Comments and Response Report – Pre-Consultation

The Proposed Development of a Primary Dwelling and Access Road on Portion 79 of Farm 205, Ruygte Valley, Sedgefield, Western Cape

Pre-Consultation PPP

Fig. 8: Slopes of >25% to <80% are evident in parts of the southern sector of the property (CapeFarmMapper3).

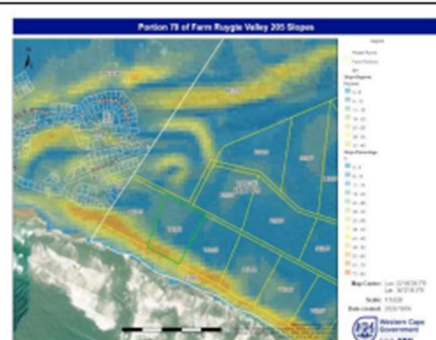
4. The site is steep, and we remind the applicant that steep slopes increase the chance of erosion and siltation which can also result in land slipping. Also, heavy rainfall events may also exacerbate the soil condition.	The applicant is fully aware of the steep terrain present on portions of the property, particularly along the southern coastal edge and recognises that steep slopes increase the risk of erosion, siltation, and slope instability, especially during heavy rainfall events. This concern is confirmed and supported by the findings of the Preliminary Geotechnical and Geomatic Report (Rock Hounds (Pty) Ltd., March 2024), which identifies that: • The southern slopes consist of unconsolidated Holocene dune sands that are poorly structured, highly erodible, and inherently unstable. • These dune slopes are highly susceptible to slumping, collapse, and deep erosion, especially if natural vegetation cover is removed.
